IV. REMARKS/ARGUMENTS

Claims 9, 16, 20, and 22-24 are currently pending in the application. The pending Office objects to the specification, drawings; rejects claims 9, 16, 23 and 24; and allows claims 20 and 22. By this amendment, the specification and claims 9, 16, and 22-24 are amended. No new matter is introduced by this amendment. Applicant respectfully requests reconsideration of the specification, drawings, and claims for at least the following reasons.

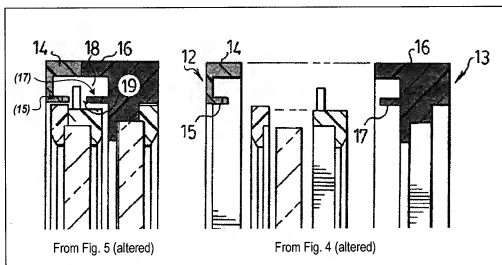
The Office Action objected to the drawings as failing show every feature of the claimed invention, such as “the walls having slot” and “reduced width channel.” Office Action, page 2. Applicant respectfully submits that the drawings, particularly Figures 4-6, illustrate each of the features presently recited in the claims. For ease of discussion, exemplary Figures 4 and 5 are reproduced below, altered for clarification.

Figures 4 and 5 illustrate components of a window unit in horizontal cross-section. As illustrated in the figures, the frame members (12 and 13) have integral laterally projecting lips (15 and 17, respectively), reducing the width of the channel (18), to form an inner wall having a slot therethrough (i.e., the slotted inner wall being formed by lips 15 and 17 and the gap 19 therebetween). For at least these reasons, Applicant respectfully submits that the drawings, without amendment, adequately illustrate the subject matter recited in the claims. Accordingly, Applicant respectfully requests withdrawal of the objection to the drawings.

Figure 2 of SUH

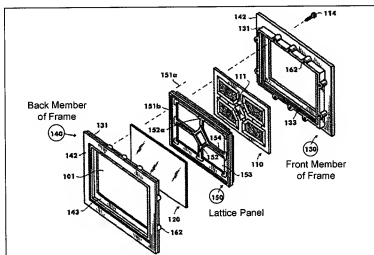
SUH discloses a prefabricated window frame, having a decorative window subassembly within. SUH, Abstract. The frame has a front member (reference number 130 in Figure 2, reproduced below), a back frame member (140), and lattice panel (150) located intermediate to the front member and the back member. *Id.* at col. 3, ll. 30-32, 44-45. Glass panes (120, 110) are situated between the back member and the lattice panel, and between the lattice panel and the front member. *Id.* at col. 3, l. 56 - col. 4, l. 4. The entire assembly is screwed or otherwise fastened together to form a unitary window assembly. *Id.* at col. 2, ll. 24-26.

However, SUH does not teach or suggest a window frame unit, having three members forming two support frames, in which one of the support frames is adapted to receive a slidable window sash, as recited in claims 9, 23, and 24. Each of the components of the window of SUH are fastened together so as to form one unit—none of the SUH window components are adapted to receive a slidable window sash, as recited in claims 9, 23, and 24. Indeed, nothing about the window unit is intended to be slidable—the SUH window panel is intended to be installed as a stationary assembly in an opening in a wall or a door. For at least this reason, Applicant respectfully submits that claims 9, 23, and 24 are not unpatentable in view of SUH.
